# HABITAT ARCHITECTURAL REVIEW BOARD

## TABBY ROADS

October 3, 2024

Lot 27, 1 BLUE CRAB ST, Bluffton, South Carolina 29910

Fig 4. – Landscaping Min Height Region

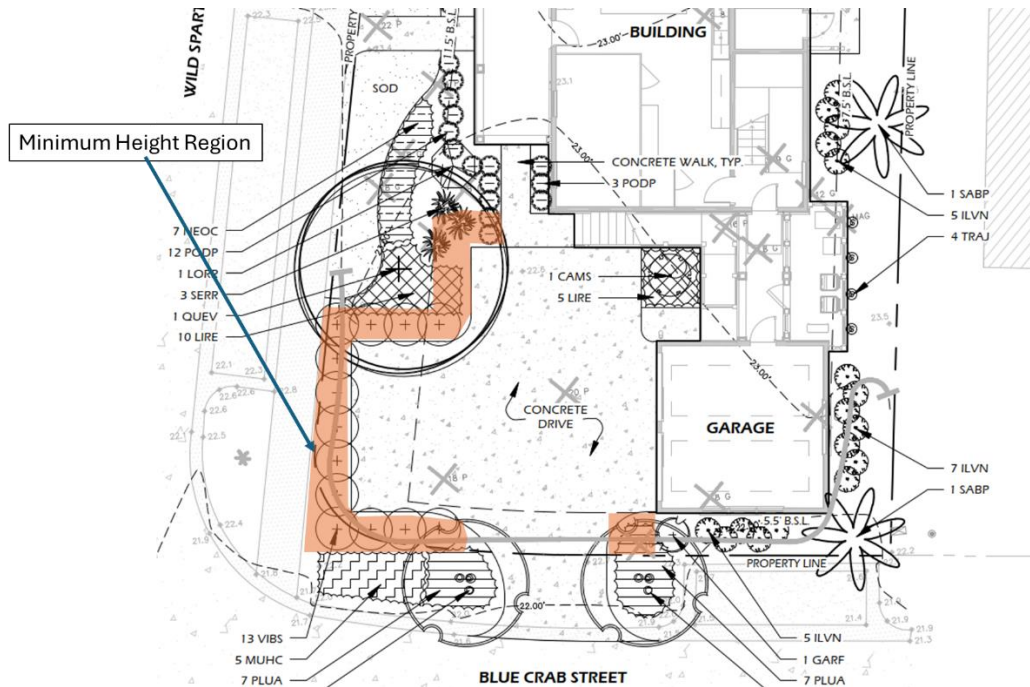
- As was discussed in the preliminary review process, there is an expectation that mature plantings will be installed to try and hide as much as possible the view of the parking area from the Wild Spartina perspective. The committee is therefore establishing a minimum height requirement of 36 inches for all initial plantings in the regions highlighted in Fig. 4. Plant species in these regions should be such that at maturity they are 6ft or taller and spaced to form a dense screening of the view of the parking area. Plant species suggestions include but are not limited to anise, wax myrtle, yaupon holly, podocarpus and/or viburnum. It is recommended that two species be intermixed to add visual interest and avoid a “long hedge line” look.
